Request for Proposal (RFP)  
Bid No. 26-05-4127SB  
Addendum No. 1

**Date:** May 20, 2026  
**To:** All Proposers  
**Subject:** Addendum No. 1  
Consisting of Sixteen (16) pages.  
**RFP No.:** Bid No. 26-05-4127SB  
**Project Name:** N8084(1)1,2&4 Road Project in Many Farms, AZ  
**Owner:** Navajo Division of Transportation

The following sheets have been revised. These sheets shall replace the corresponding sheets in the N8084(1) Many Farms Roadway Improvement Project Bid Plans. The revisions have been clouded and denoted as Amendment No. 1.

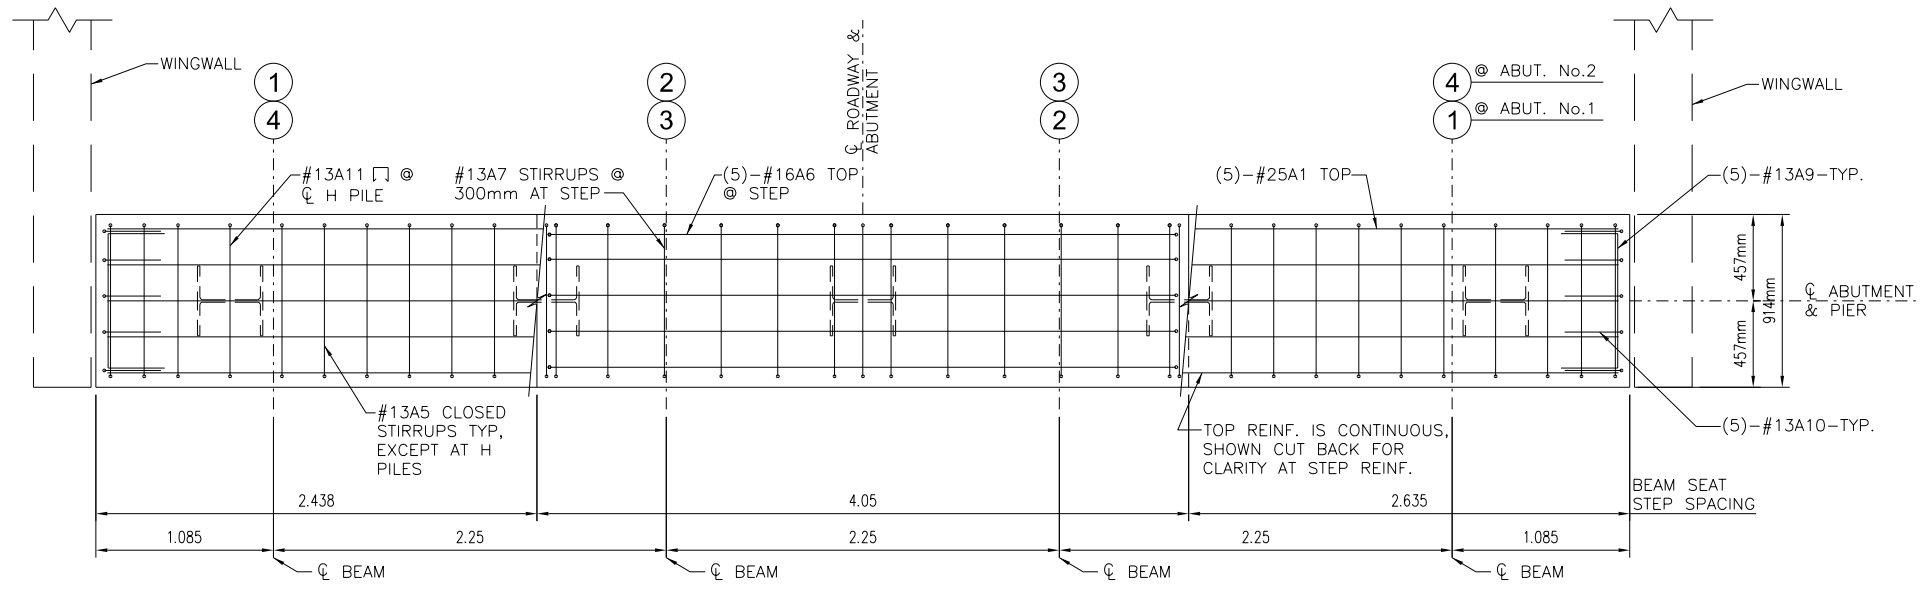
**Q3.** The job appears to have 12EA 1243mm (45” tall) and 12EA 914mm (36” tall) AASHTO Type 2 I-Girders. Our precast yards don’t have forms for those specific shapes, but we do have forms for CALTRANS I-girders which are very similar. CALTRANS I-girder shape attached (of note the increments in attached are every 6”, but we can cast them at whatever height is needed so matching current design heights are not an issue). Requesting approval for substitution for CALTRANS I-Girder shapes in lieu of AASHTO I-Girder shapes.

**A3.** As a precast concrete supplier to the bidding General Contractors, you can provide pricing for CALTRANS I-girder shapes at the discretion and acceptance of the bidding General Contractor. In accordance with the Contract Book for N8084(1) 1,2, &4 Many Farms-US 191 to Sand Cone Springs, Article 6.5, the CALTRANS I-girder shapes are considered a proposed Substitute Item (Article 6.5.A.2). In addition, and as stated in the Contract Book (Article 6.5.A.2), “Requests for review of proposed substitute items will not be accepted by Construction Manager from anyone other than Contractor”; where Contractor is defined as “The individual or entity with whom Government has entered into the Agreement.”

## CHINLE WASH BEAM BEARING DETAILS

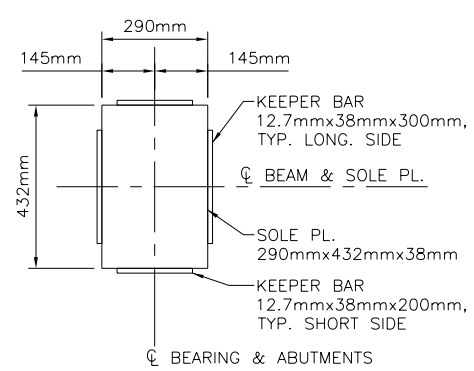
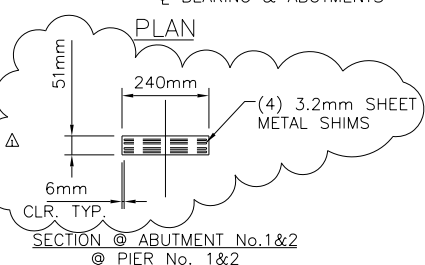
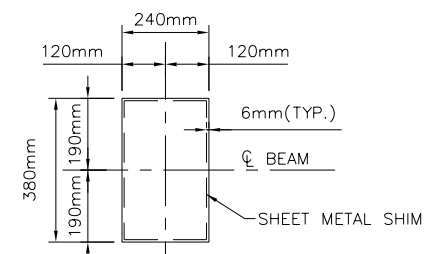
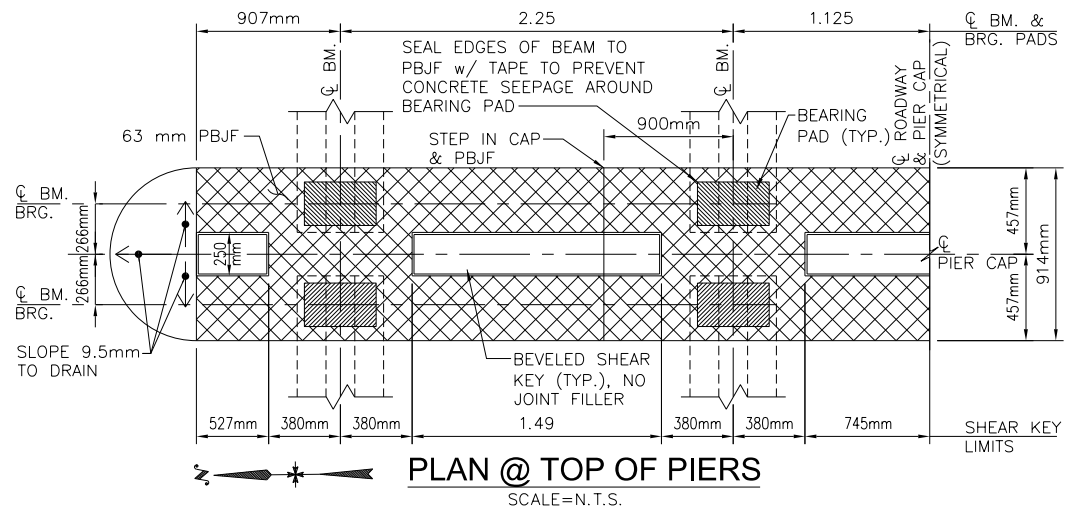
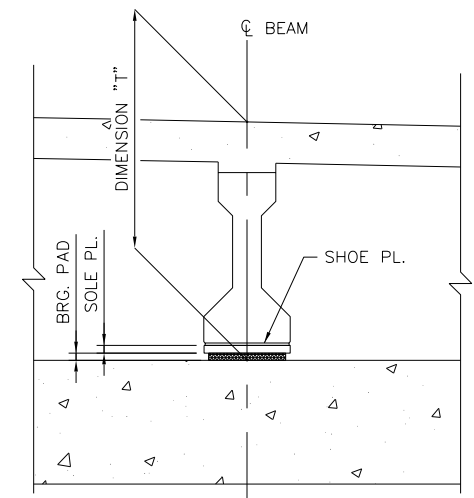
**Q1.** Chinle Wash – Sheet 62 of 109 (DWG B13)

The bearing pad detail shows a thickness of 25mm. However, the bearing pad schedule calls for an “H” dimension of 51mm, which I’m assuming is related to thickness. Please clarify what is required.

**A1.** The project plans have been revised in response to this question. Please see the revised plan sheets here in Addendum No. 1.

## SHEEP DIP WASH BEAM BEARING DETAILS

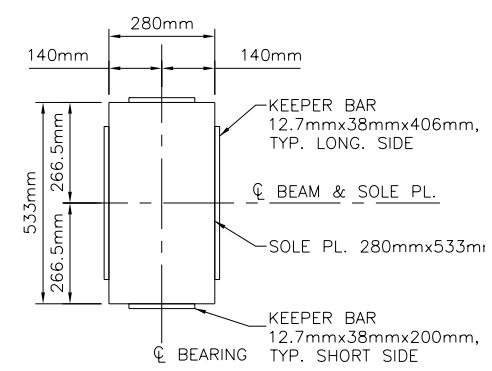
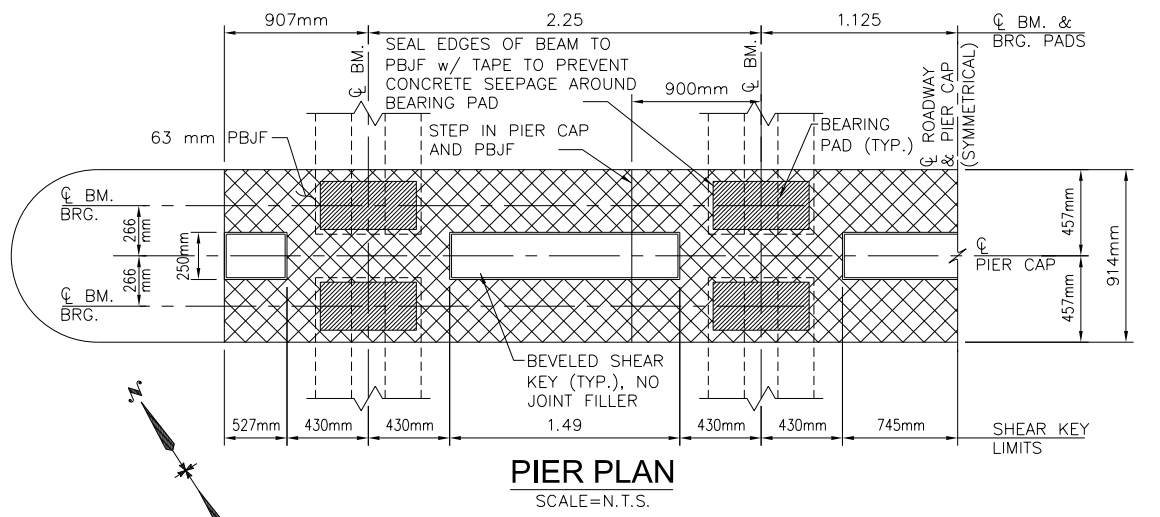
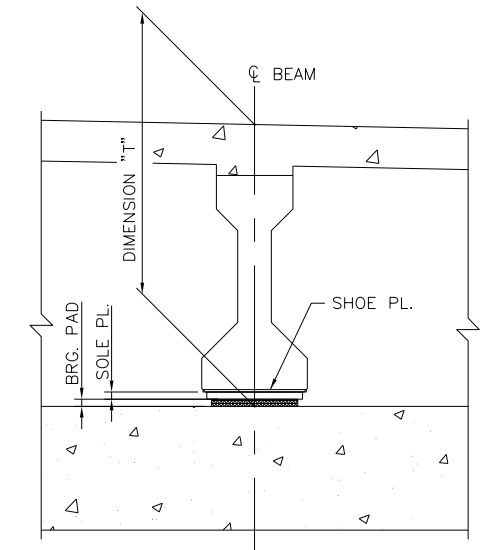
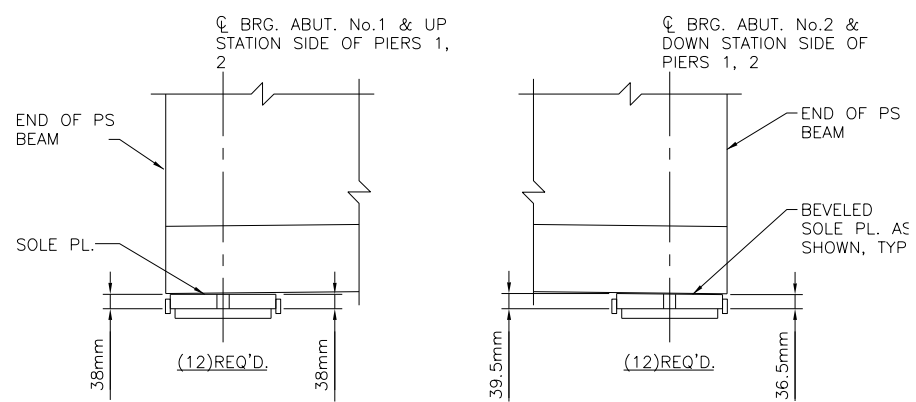
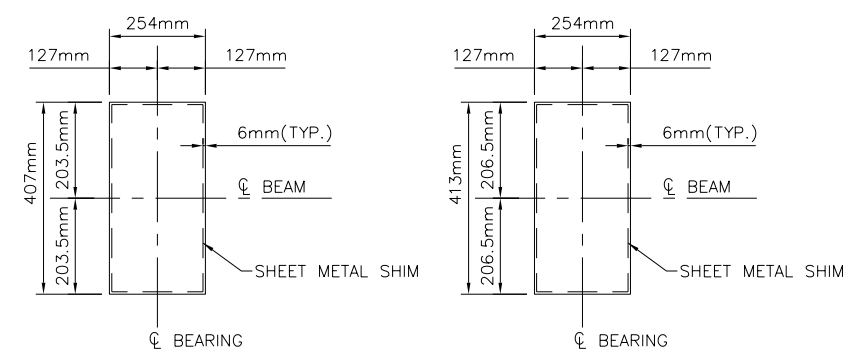
**Q2.** Sheep Dip Wash – Sheet 85 of 109 (DWG B36)  
The bearing pad detail shows a thickness of 25mm. However, the bearing pad schedule calls for an “H” dimension of 51mm, which I’m assuming is related to thickness. Please clarify what is required.

The bearing pad details show 3 metal shims. However, the bearing pad schedule calls for 2. Please clarify.

**A2.** The project plans have been revised in response to this question. Please see the revised plan sheets here in Addendum No. 1.
